N9048B-05

Modification Recommended Service Note

N9048B PXE EMI Receiver

The Problem – Signal amplitude loss can occur in Band C/D with Accelerated Time Domain Scan (ATDS) ON on N9048B option 503 (3.6GHz)

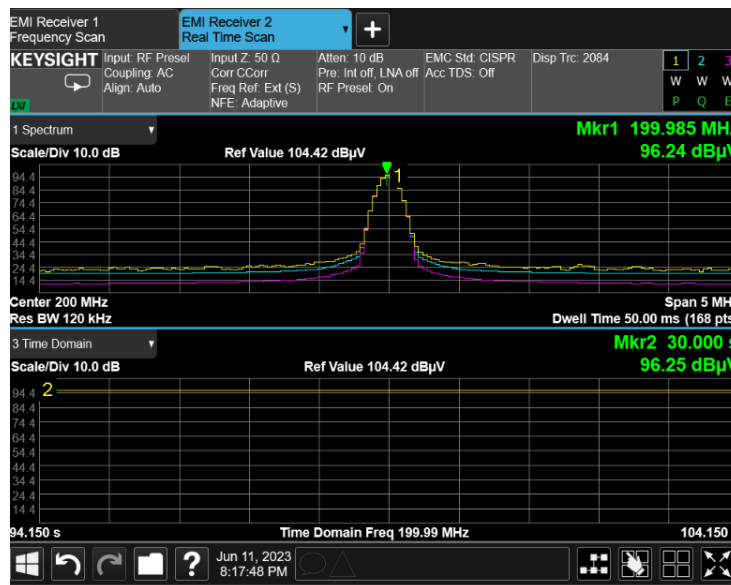
There could be an amplitude loss up to 6dB with ATDS ON in Band C/D on N9048B Option 503 after firmware upgrade/ downgrade. The calibration file was overwritten during the firmware upgrade/downgrade process. The calibration file could not be recovered due to option 503 will not run ScarletDualWBDifPhaseAlignmentAlgorithm as this alignment run with 4.8GHz calibration signal which only enable for high frequency option.

This issue only appears on instruments with option 503.

Download and install instrument software A.36.02 or later. This software enables ScarletDualWBDifPhaseAlignmentAlgorithm run with 4.8GHz calibrator signal on N9048B Option 503 to recover the calibration file.

To verify the issue has been resolved, power cycle the instrument after software upgrade. Connect the N9048B to a source with Frequency 200MHz with -10dBm input power. Setup the N9048B in Real Time Scan mode with Center frequency 200MHz. Switching between ATDS OFF and ON and make sure the amplitude reading is consistent and no loss with ATDS ON.
